**SUBJECT: TREE REPLACEMENT
MEMORIAL, ISHAM & RAYMOND ROAD
SPECIAL DEVELOPMENT DISTRICT ADMINISTRATIVE
AMENDMENT (SDD #113-R1-16)**

I have received an administrative amendment request from John Philips, Director of Public Works and West Hartford Tree Warden, for revisions to the approved Special Development District plan (SDD #113) located within the street right of way along Memorial, Isham and Raymond Road. The request is for minor modification to the size of the approved plantings. In this instance, the replacement of a total of 12 streets trees, 4 Chinese Elms along Raymond Road and 8 London Plane trees located at the corners of Isham and Memorial.

Re: Tree replacement in Blue Back Square

West Hartford Town Center Street Trees Assessment and Recommendations

Photo # 1

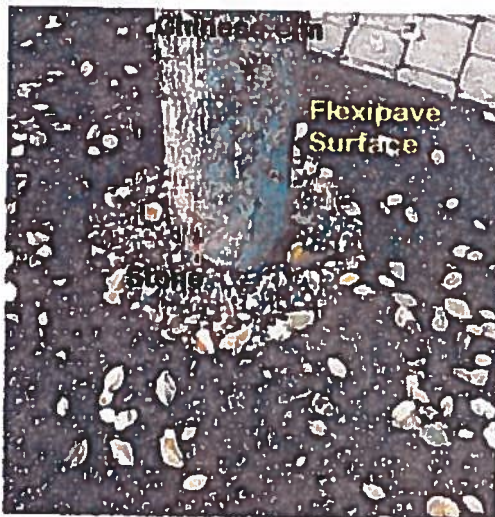
Root collar investigation reveals planting depth in London Plane and Chinese elm too deep.

Photograph # 1 above showing surface texture with no visible root flare at surface.
Photograph # 2 showing poor condition, limited foliage and healthy buds.

Photo # 4 Flexipave thickness 4"; Gravel Thickness 4 "

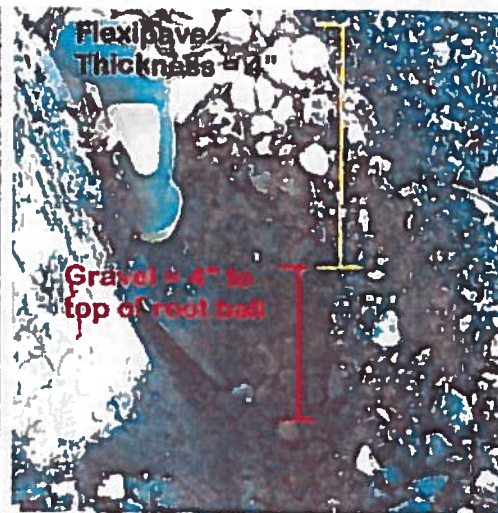
Root collar excavations (RCE) confirm that planting depth in the locations sampled were too deep. London plane trees examined averaged 12" to 14" below surface grade and Chinese elms were found to be 8" to 10" below. Adventitious roots from 1/8 to 1/2 "were found when performing the RCE on both London Plane trees sampled. This is consistent with the trees attempt to regain access to necessary physiological needs. The size of roots found in this capacity would not be sufficient to sustain this tree over time. Whether the depth of planting was due to "soil subsidence" can not be determined using RCE but this condition can occur when the soil below the installed tree is not sufficiently prepared and the root ball settles resulting in subsidence. Based upon observation of the tree caliper size of the London Plane trees, the root ball at time of planting would be estimated to be from 60" to 72". In order to determine if the soil heterogeneity is a factor, panels in the sidewalk would need to be opened to permit sampling of soils surrounding the planting pit. Poor conditions in both the Chinese elm and the London Plane are consistent with decline due to improper planting depth. Additionally, evidence of vascular damage to the outer and inner bark tissue is evident at the base of London plane trees sampled for RCE. (See Photographs # 5 & # 6 on the following page). The Chinese elms sampled by RCE exposed the profile of the Flexipave. This material was approximately 4" in thickness. Following this layer was a layer of @3/4" crushed stone to a depth of approximately 8". Beyond these two materials lay a sandy mix of soil which may be the material from the nursery. Soil moisture was not measured but soil beneath the mulch in London plane was visibly dry.
